**Northeast Service Center Underground Storage Tank Permanent Removal
Solicitation Number: B-20-006-FG
Job No.: 20-0122**

**ADDENDUM #1
July 21, 2020**

UST DEMOLITION SITE PLAN

REF. NO. C-2 (Rev 1)
 SHEET 5 OF 6

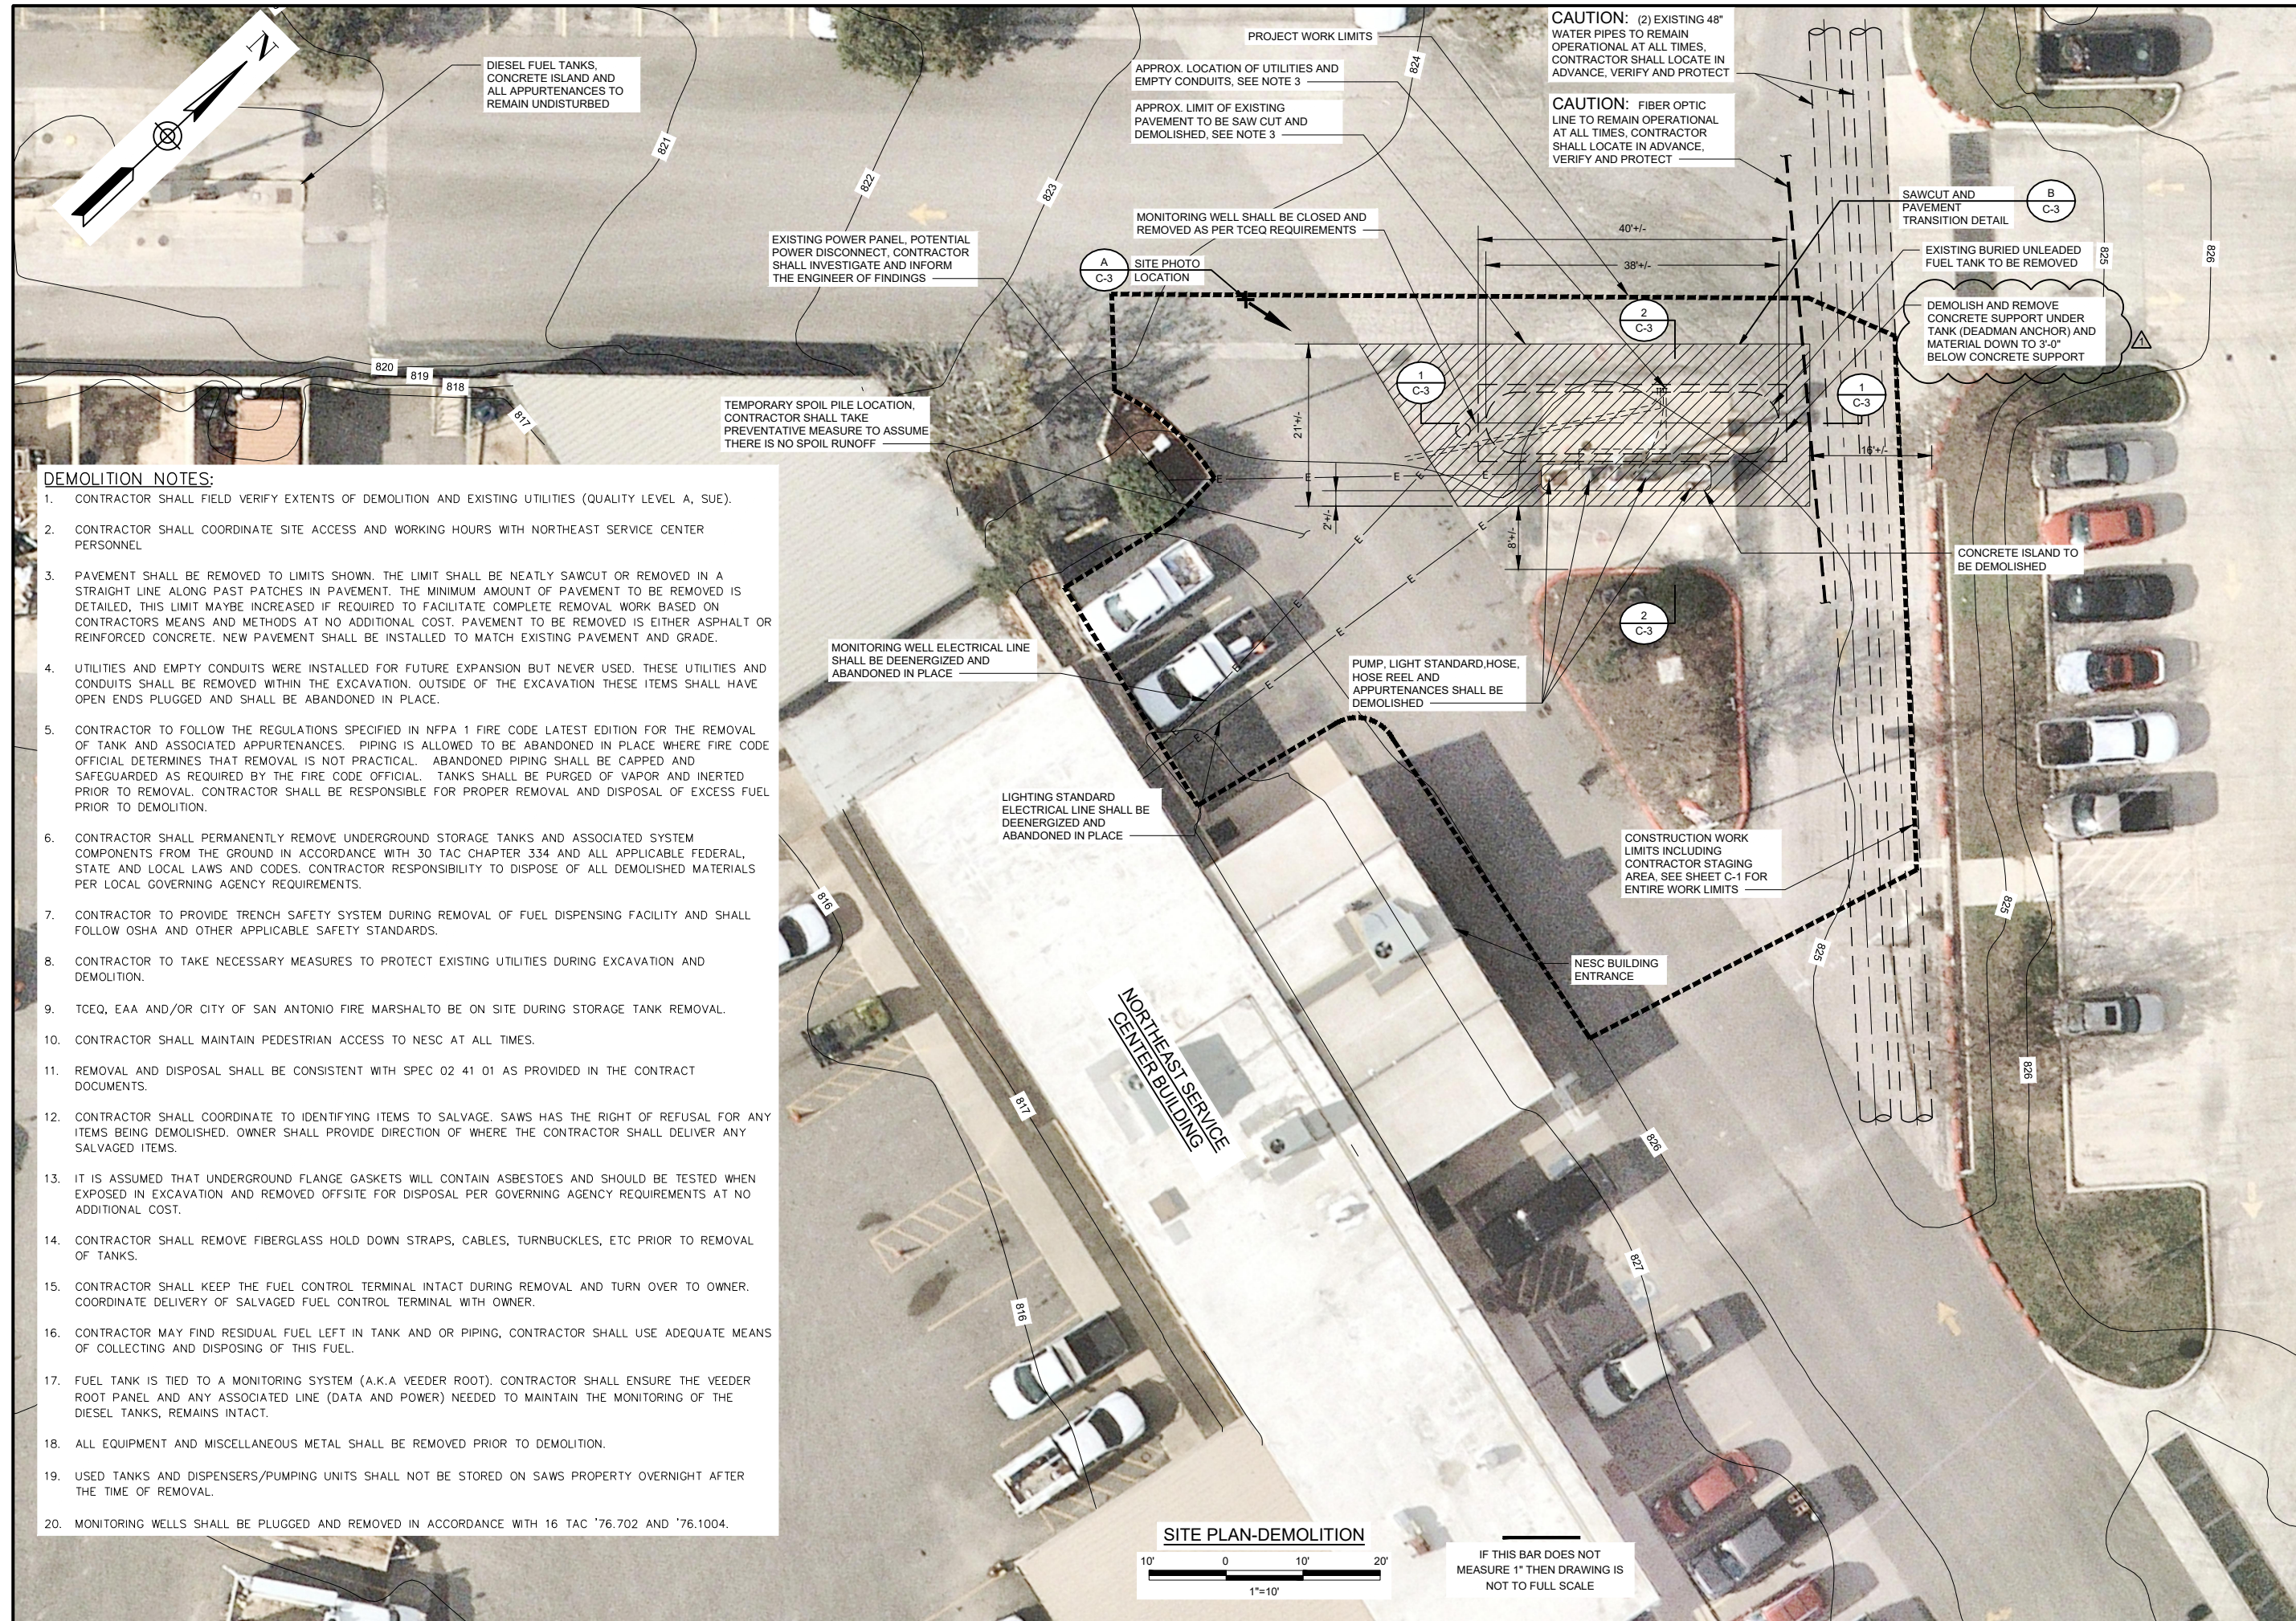
1. As shown on Attachment A, Plan Sheet C-2 has been updated to clarify requirement for the removal of the concrete pad (deadman anchor) below the tank, as specified.

NO.	DATE	REVISION	BY
1	7-14-20	NOTE MODIFIED	BS
